13 October 2021

**RESPONSE TO REQUEST FOR ADDITIONAL INFORMATION
FORT STREET PUBLIC SCHOOL, SECTION 4.55(2) MODIFICATION APPLICATION (SSD-10340)**

Figure 1 View comparison between original section 4.55 scheme and amended proposal

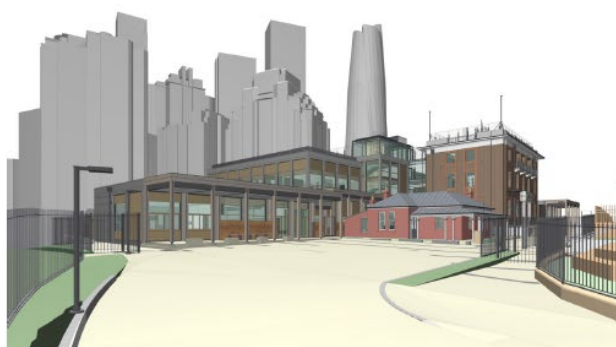
Heritage NSW, the SDRP, the Lord Mayor and Council have raised concerns over the bulk and visual impact of the additional partial storey to Building J that was proposed in the original Section 4.55 scheme. While Council acknowledged that the impact of the partial additional level needs to be balanced against other aspects of the modification which seek to improve heritage outcomes on the site, such as relocation of the lift from the Met Building to Building J, Council suggested that the bulk of Building J could be reduced without compromising the design. As such, the Lord Mayor and Council have requested that SI NSW consider deleting the roof from the top of the south stair and plant area and lowering the screening of the plant deck so that it does not read as a full floor. The SDRP followed with additional feedback on a number of design options presented at SDRP 5 on 1 September 2021 that incorporated Council's suggestions.

Heritage NSW echoed these concerns, stating that the modification scheme would adversely impact on the heritage interpretation of the Met Building, including views to and from Observatory Hill.

In response to feedback from Heritage NSW, the Lord Mayor, Council and the SDRP, changes have been made to reduce the bulk and scale of the Building J rooftop to mitigate visual and heritage impacts.

This has been achieved through the relocation of plant areas, a reduction in the extent of the lift and stair enclosure, and improved transparency so that the additional partial storey to Building J is effectively removed. These changes have been made in consultation with the relevant agencies.

Refer to the Information Package prepared by FJMT (**Attachment A**) for further detail on the new amended design. These changes are discussed further below. A comparison of the originally proposed Section 4.55 scheme and the amended scheme, from key vantage points within the site, is provided below in **Figure 1**.

Figure 9 Proposed rooftop shade provision (Level 2 shown)

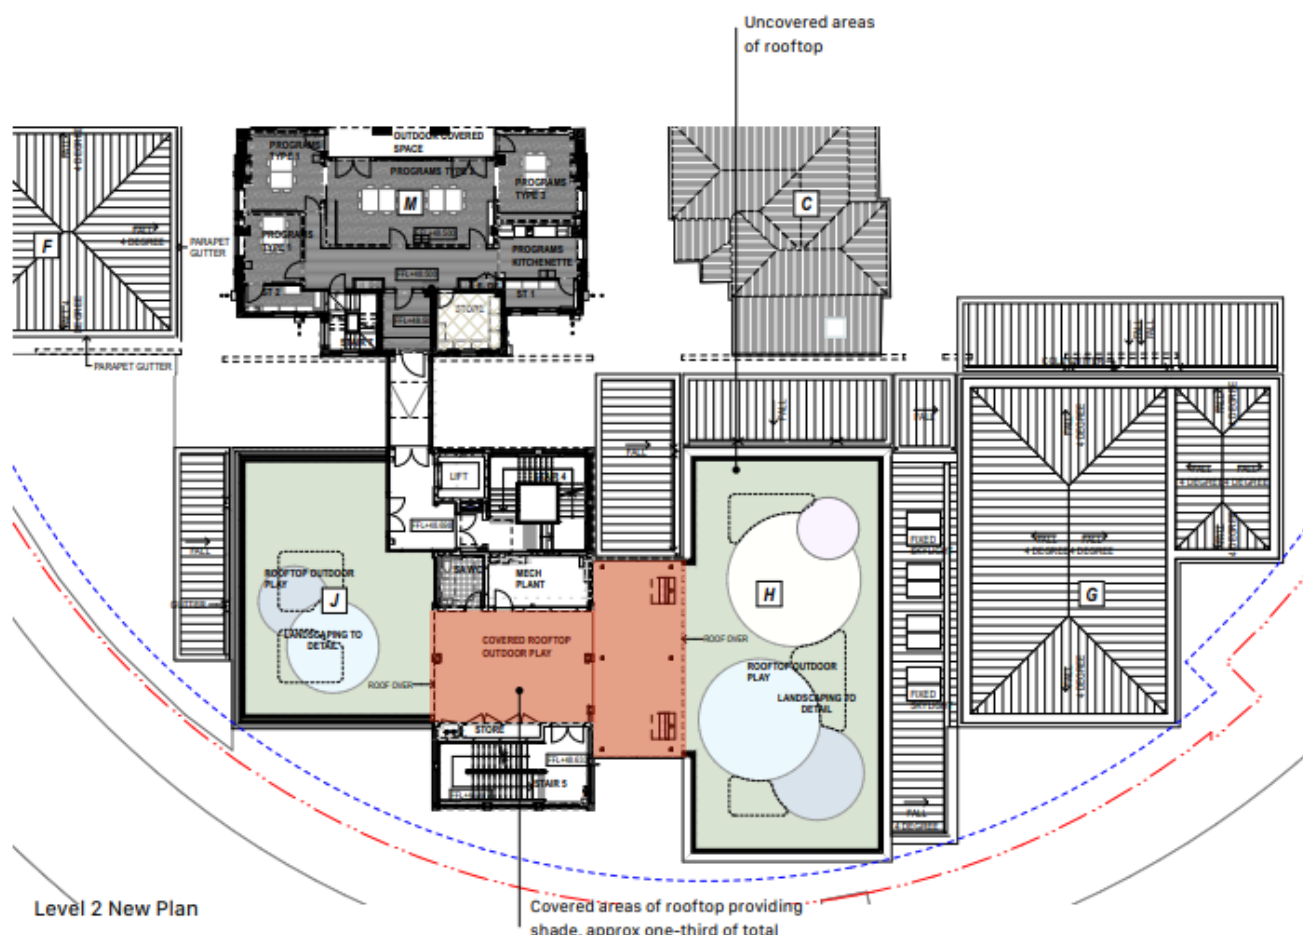
Council have continued to raise concerns regarding the design of the rooftop play space, including recommendations to provide additional shading and that soft fall is not a suitable finish.

The landscape design of the rooftops has been driven by requests from various stakeholders to reduce the visual impact of Building J. As such, design factors including height, bulk and scale have been ongoing considerations during the design process. Recently, there has been significant effort by SI NSW and the design team to further reduce the bulk and scale of Building J to address these concerns. Incorporating shade structures would be conflict with these initiatives, and would reintroduce bulk and scale at roof level. This would be contrary to advice received from key stakeholders such as Heritage NSW.

The landscape design for the rooftops has also been developed in conjunction with FSPS representatives and SI NSW, and responds to end user requirements and the need for fit-for-purpose play areas. Safety in design has also been a key consideration in the rooftop design, with fixed shade structures being eliminated to keep the rooftop play space clear of fixed columns for child safety. Similarly, perimeter planting and fixed seating has not been progressed due to Safety in Design risks and the potential to create climbing hazards. This is a particularly important consideration given the site's proximity to the Cahill Cut.

Notwithstanding, one third of the rooftop is still proposed to be under a solid roof cover to provide shade and relief from the sun and rain without compromising student safety. In accordance with the approved SSD, no shading is provided on the eastern and western wings of Buildings J/H. The proposed rooftop shade provision is shown below in **Figure 9**.

Figure 10 Stamford Marque - Existing floorplan

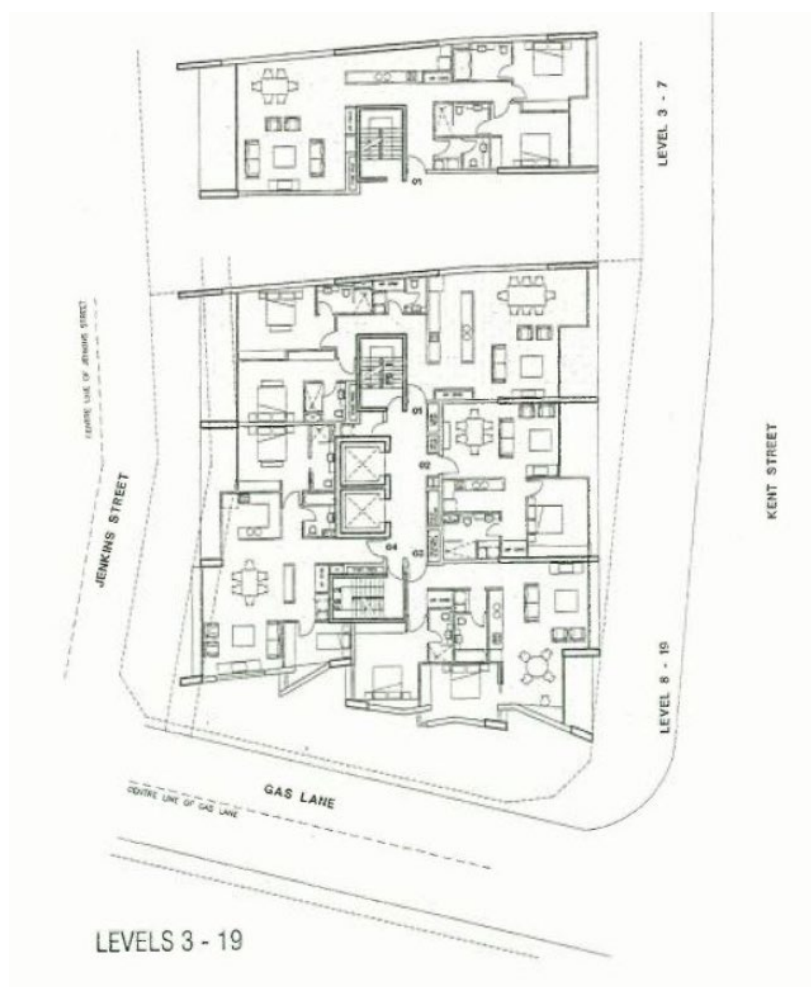
In addition, two public submissions received from residents living at Level 7 of the Stamford Marque, located at 161 Kent Street, have raised concerns regarding view impacts from their apartments. These apartments were not included in the Visual Impact Assessment (VIA) that was submitted with the Modification Response to Submissions, as they were below the datum line that was taken from the top of the Met Building roof (RL 52.712m) and used as a basis for low-level views. Therefore, DPIE has requested that additional view impact assessment be undertaken for these two properties.

Based on archival records obtained from Council, there are living rooms, balconies and bedrooms on the eastern frontage of apartments between Levels 3 and 19 (refer to **Figure 10**).
